NOTES ABOUT PUBLIC PARTICIPATION = RED

## (1) SP2022-030 (BETHANY ROSS)

PROJECT NAME: Amended Site Plan for a Restaurant

06/23/2022: SP2022-030; Amended Site Plan for Velvet Taco

SITE PLAN

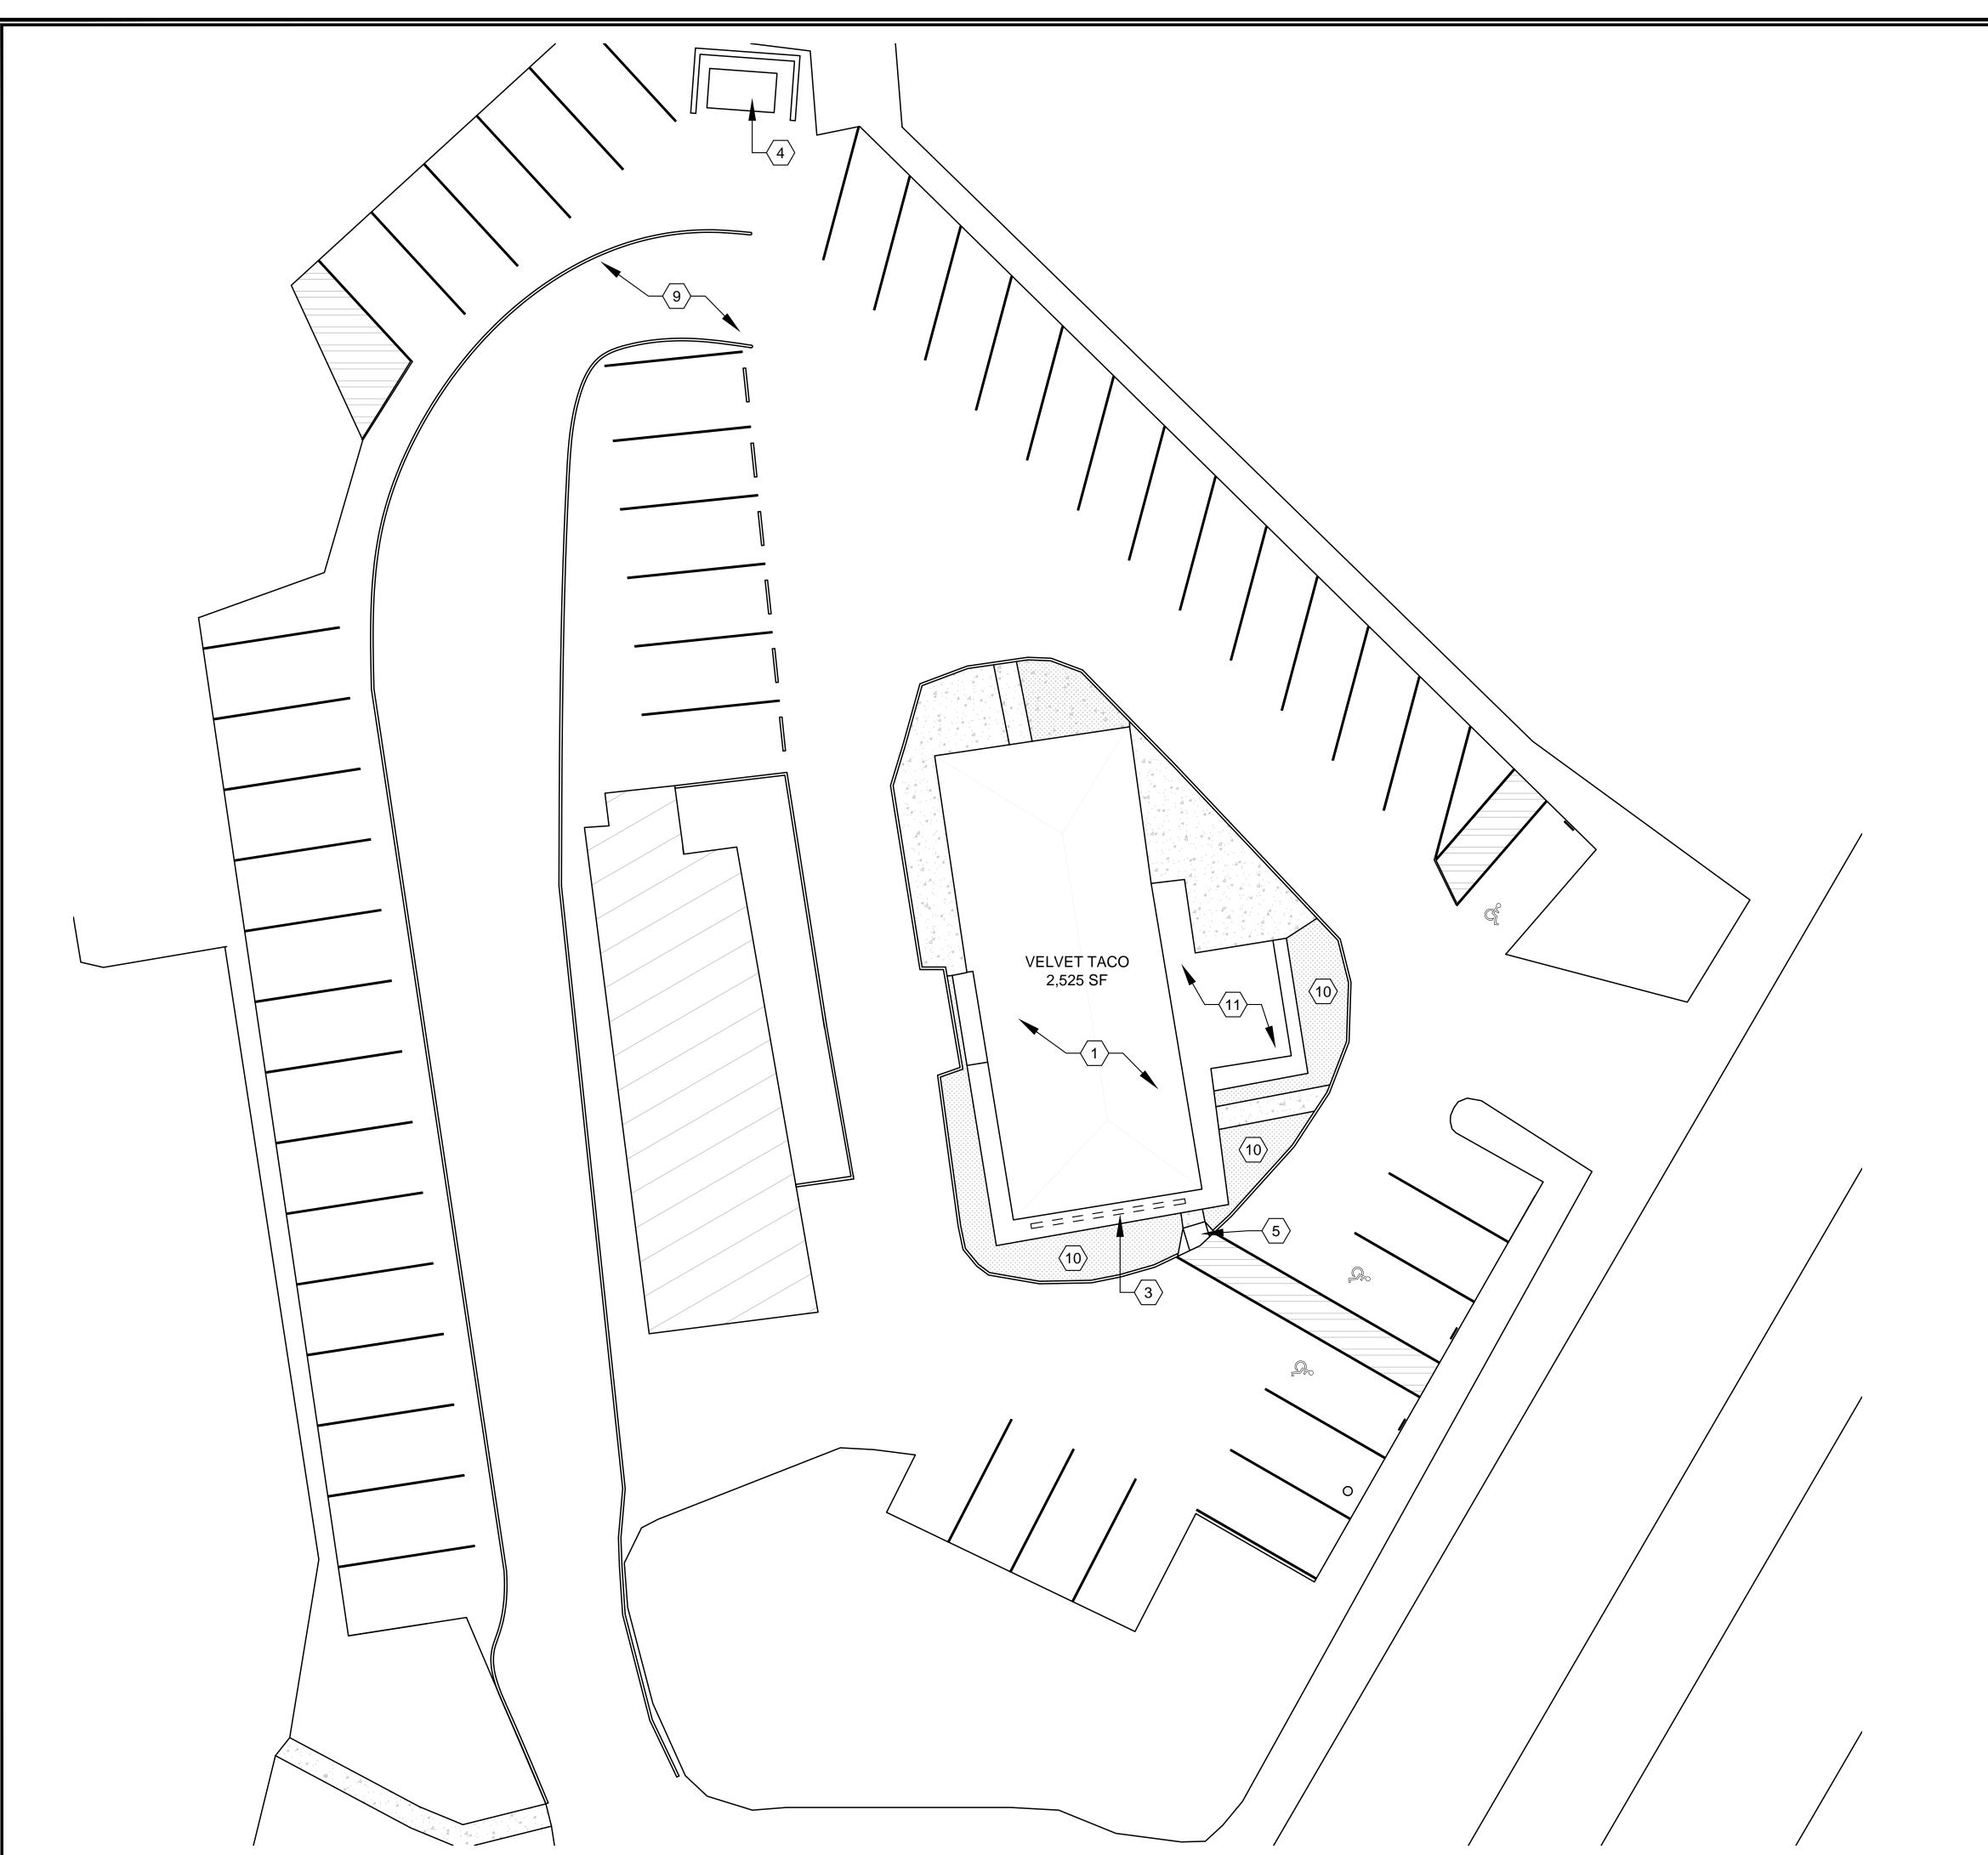
- (1) Add a North arrow. (Subsection 03.04.A, of Article 11)
- (2) Add the total lot or site area (in square footage or acreage. Indicate only the property in question on the site plan (i.e. exclude the Waffle House property). (Subsection 03.04.B, of Article 11)

- (13) Provide a parking table indicated the total number of required parking spaces (i.e. 26) and the total number provided. (Subsection 05.01, of Article 06)

- (14) Currently the site plan shows 23 parking spaces on the subject property, 26 is required. Please indicate if there is a shared parking agreement with the Waffle House property and provide staff with the agreement. (Table 5, Article 06)

- (15) Are there any roof mounted or pad mounted utility equipment? If so, indicate them on the site plan and building elevations and show any subsequent required screening. (Subsection 01.05. C, of Article 05)

PD CONCEPT PLAN

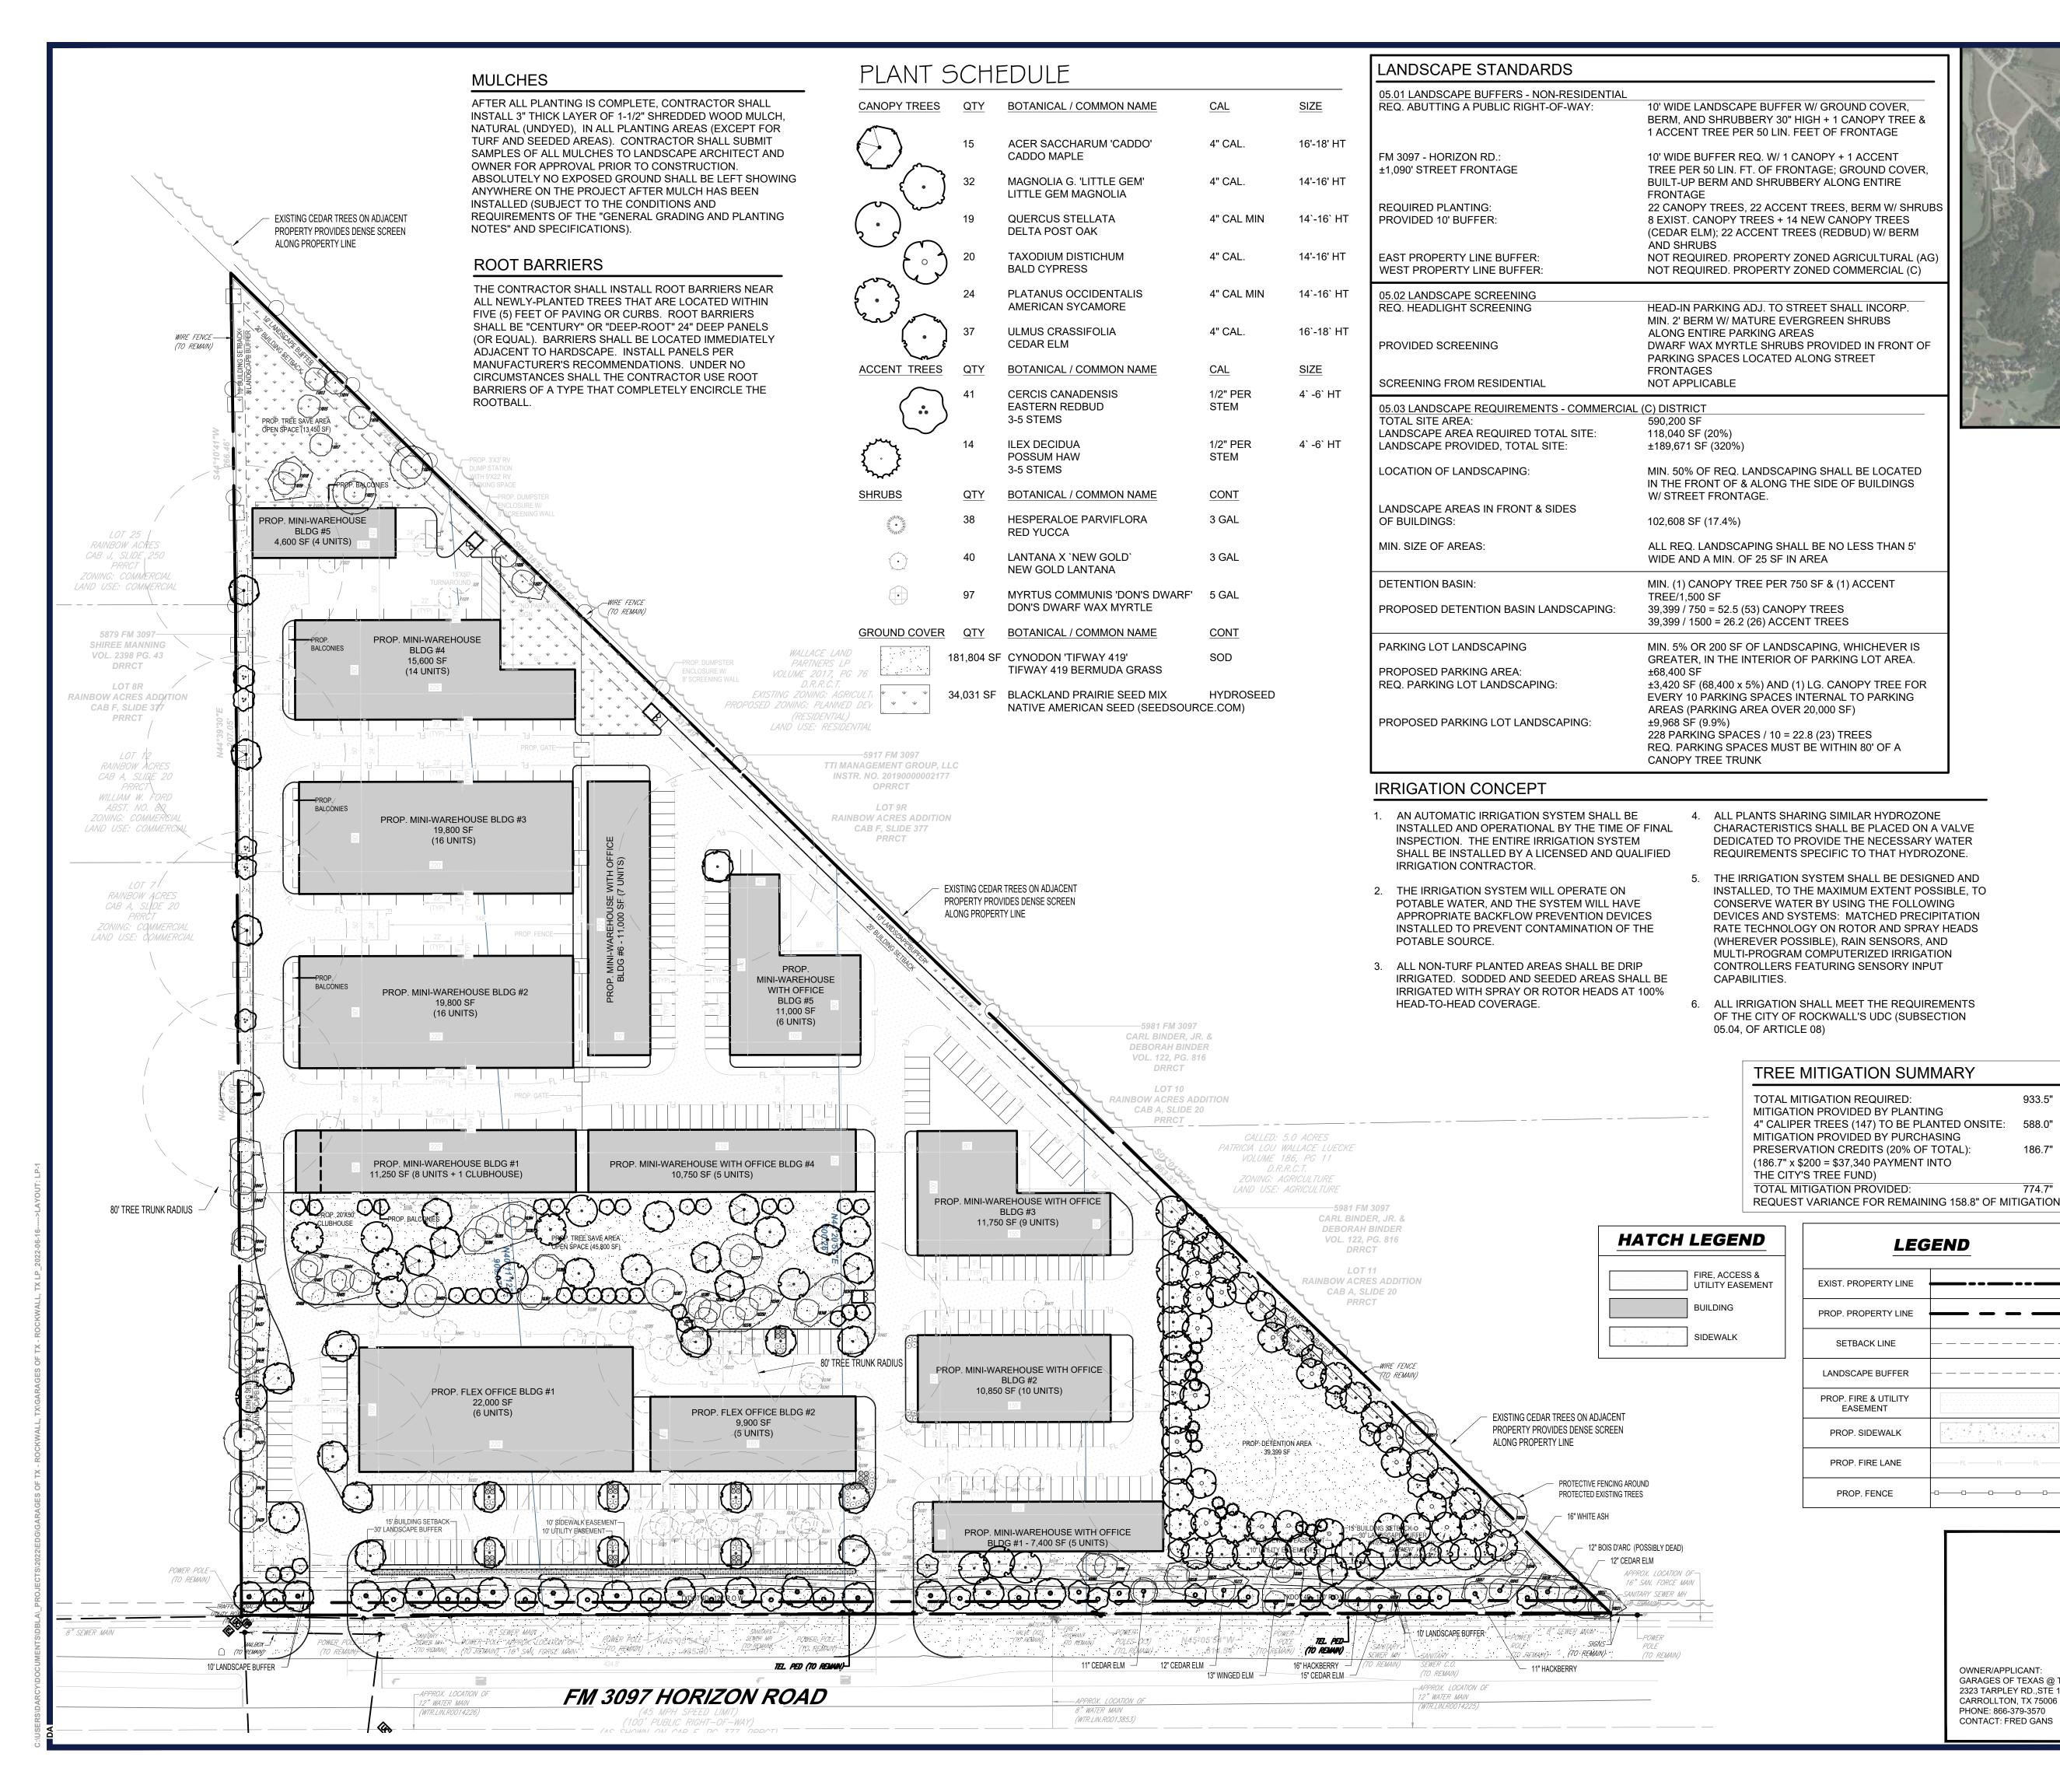
- 1. On the Site Data Summary Table under Legal please remove the existing zoning and land use and change the proposed zoning and proposed base zoning to current. (Subsection 03.04. B, of Article 11)

- 2. The Site Data Summary Table should show both the code requirement and how your project complies. For instance, for impervious cover it has only the code requirement but not the calculation for your project. Please update the table to show both. (Subsection 03.04. B, of Article 11)

- 3. Indicate each wall that will be fire rated. (Subsection 03.04. B, of Article 11)
- 4. Dumpster enclosures cannot be located in building setbacks. Please correct the site plan to reflect this. (Subsection 03.04. B, of Article 11)

- 7. On the landscape plan it shows proposed fencing, this must be indicated on the site plan. Also include the proposed height and type of fencing. (Subsection 03.04. B, of Article 11)

- 10. The dumpster enclosures must be constructed with a self-latching gate. Please update the plans to reflect this. Also, the enclosures must have 5-gallon shrubs planted around it. Please indicate this on the landscape plan. (Subsection 01.05. B, of Article 05)
